ADDENDUM NO. 1

Project: Oak Ridge Turnpike Intersection Pedestrian Safety Improvements
Oak Ridge Project No.: FY2018-139
TDOT PIN: 122976.00
TDOT Project No.: 01LPLM-F3-031
Federal Project No.: TAP-STP-M-9115(20)

This Addendum becomes part of the Contract Documents and amends or supplements the original plans and specifications as noted below.

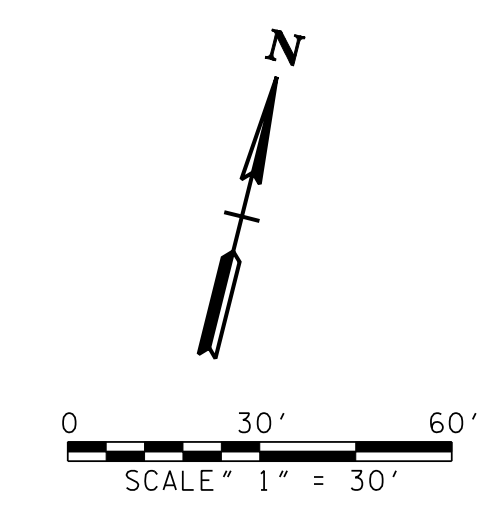
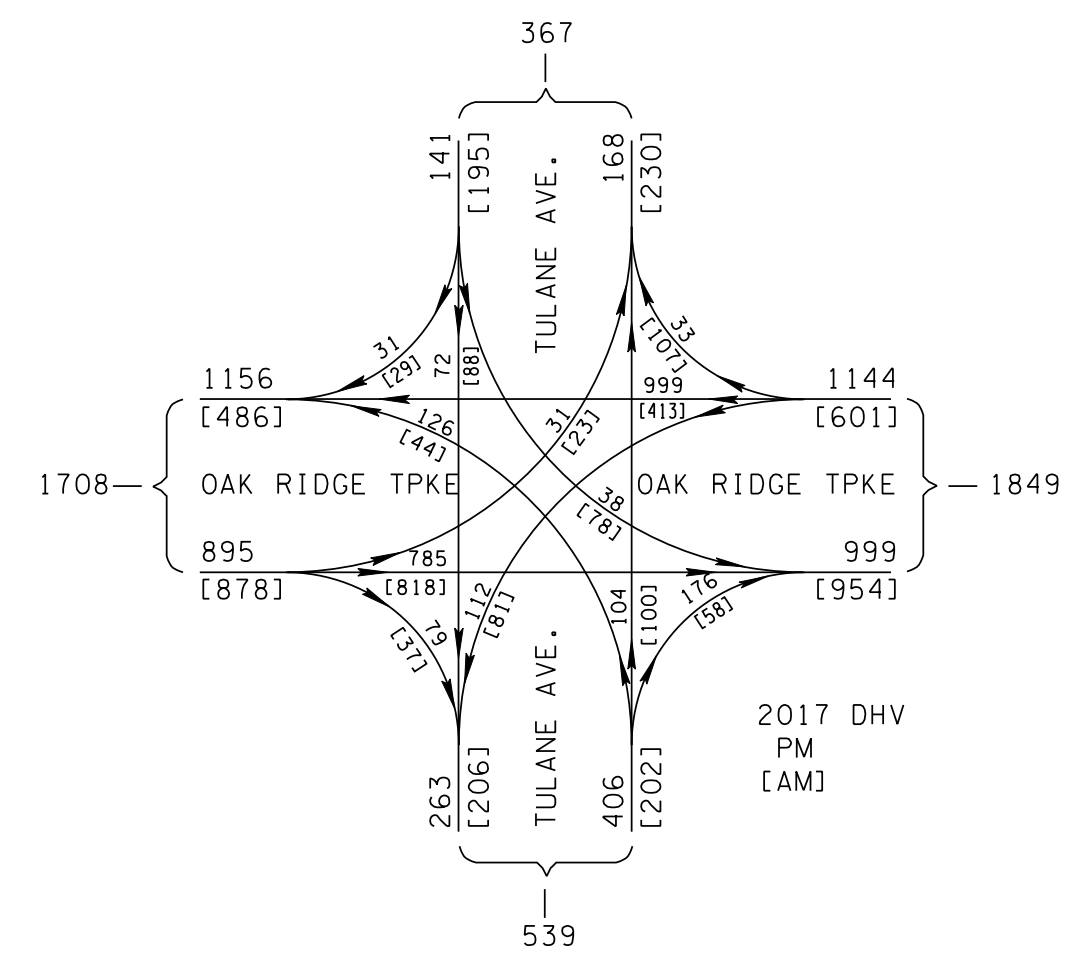
- 611-09.01, Adjustment of Existing Catch Basin, 3 Each
 7. Sheet 4A was revised to include a flagged note to install a new truncated dome surface on the existing curb ramp in the southwest corner.

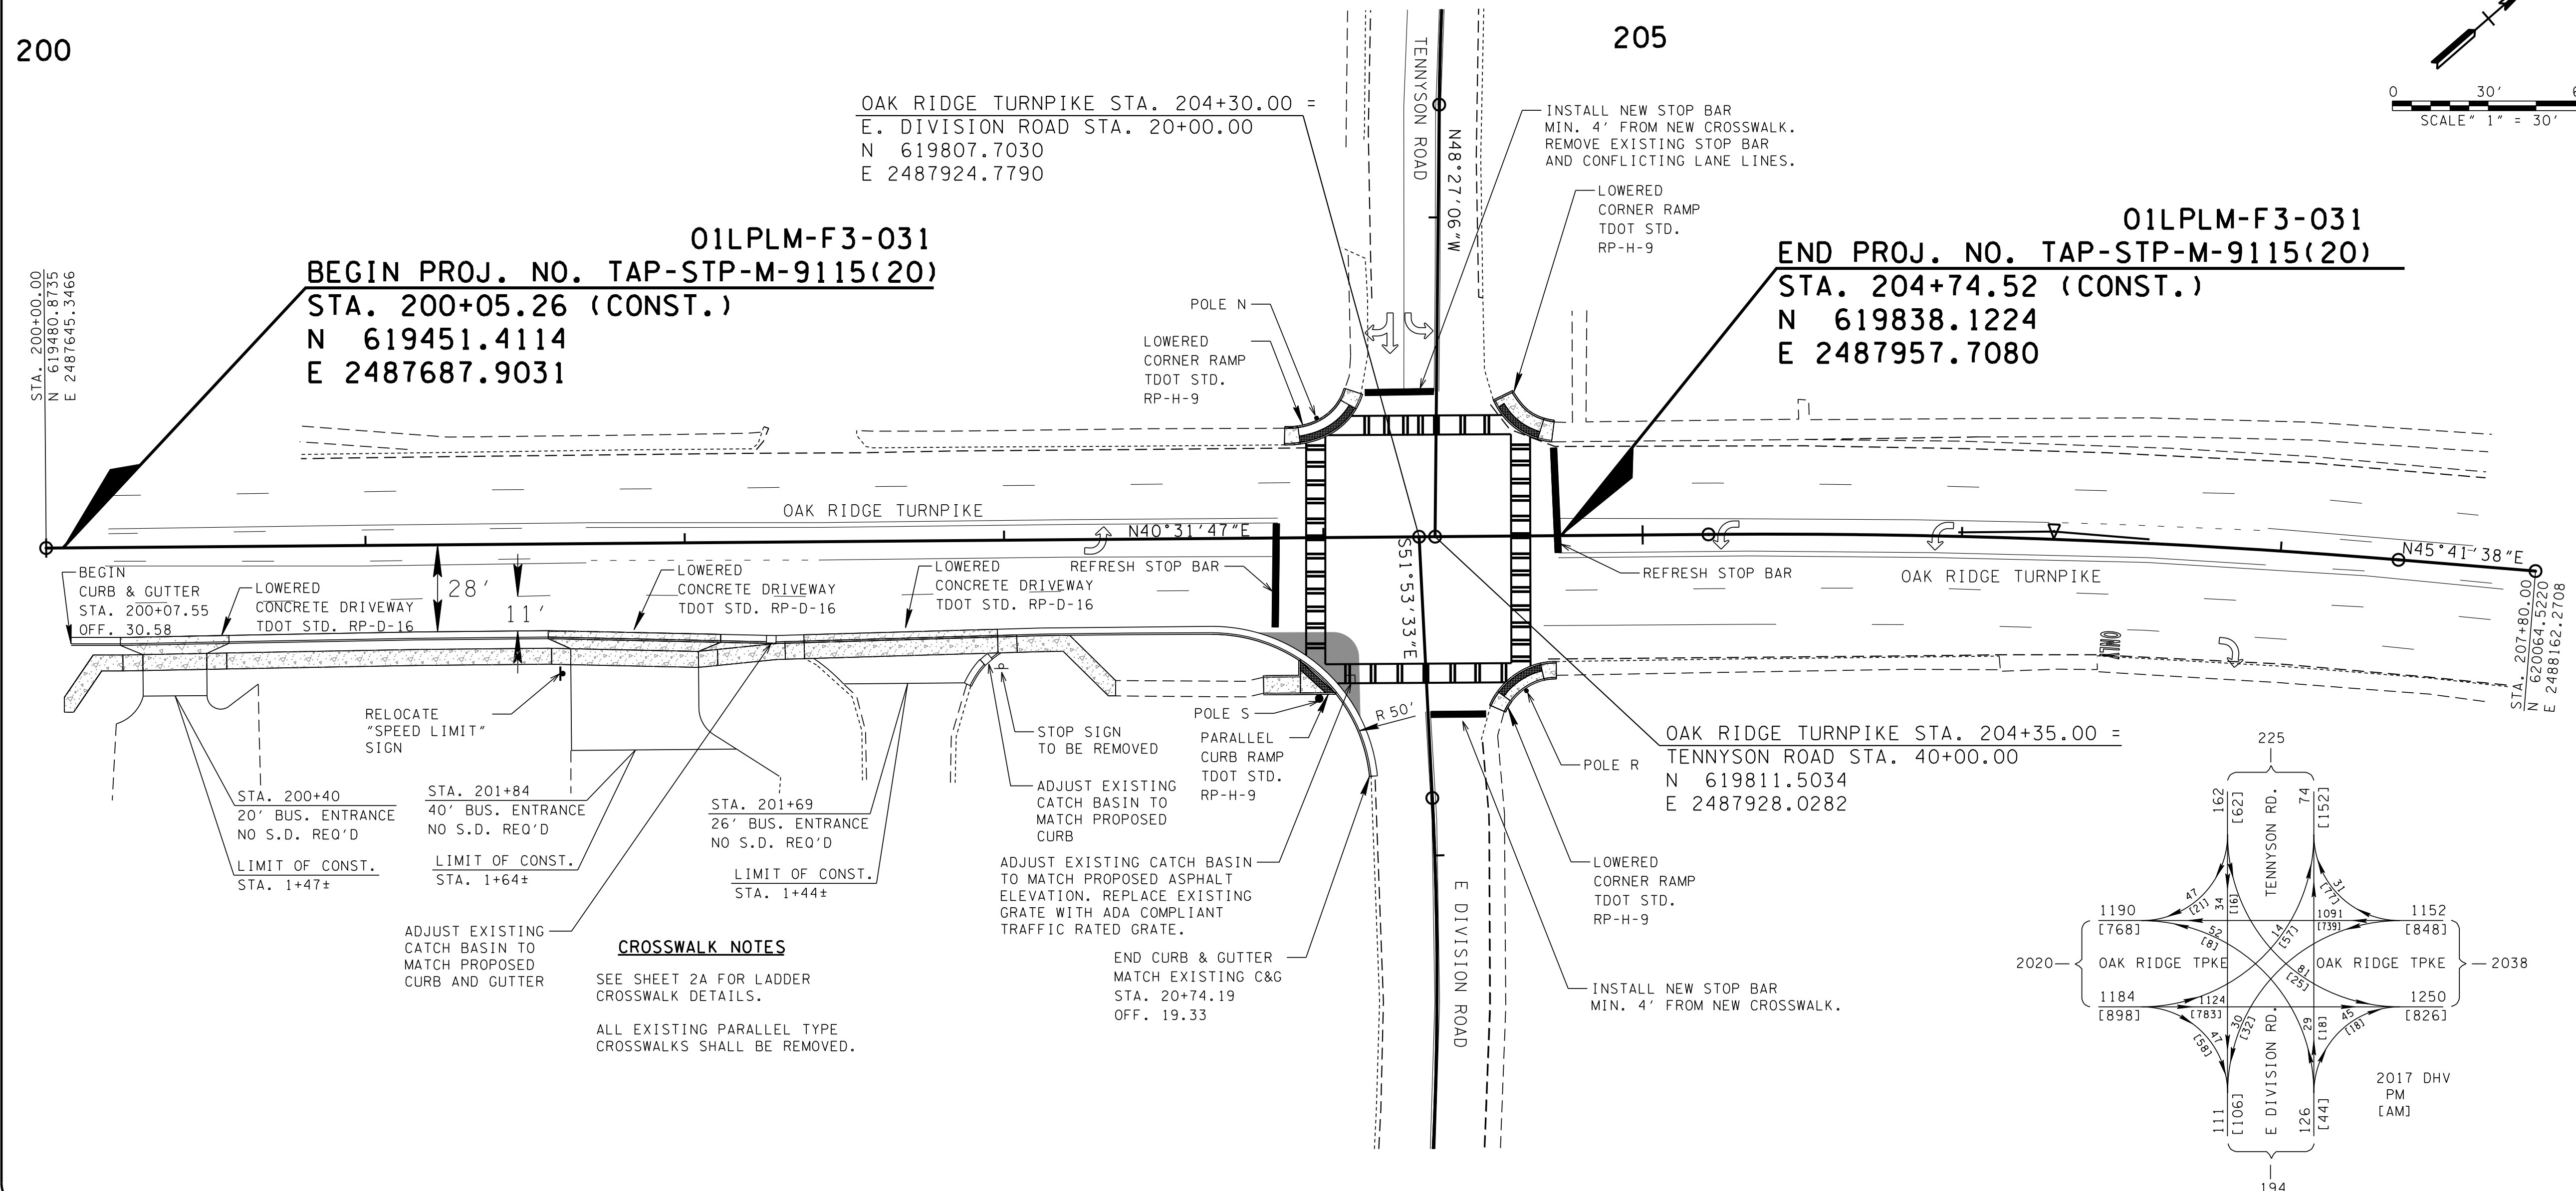
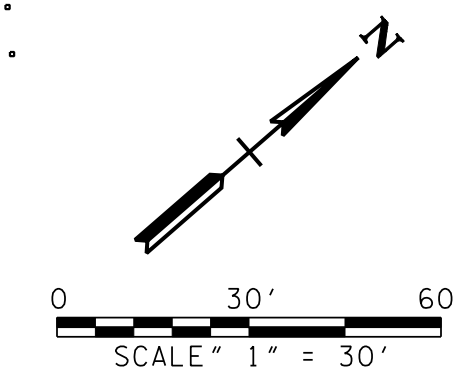
8. Sheet 5A was revised to include flagged notes to adjust existing catch basins on the south side of the Turnpike.
 9. Bidders must acknowledge receipt of this Addendum by initialing and attaching it to the inside front cover of the bound Bid Proposal Contract.
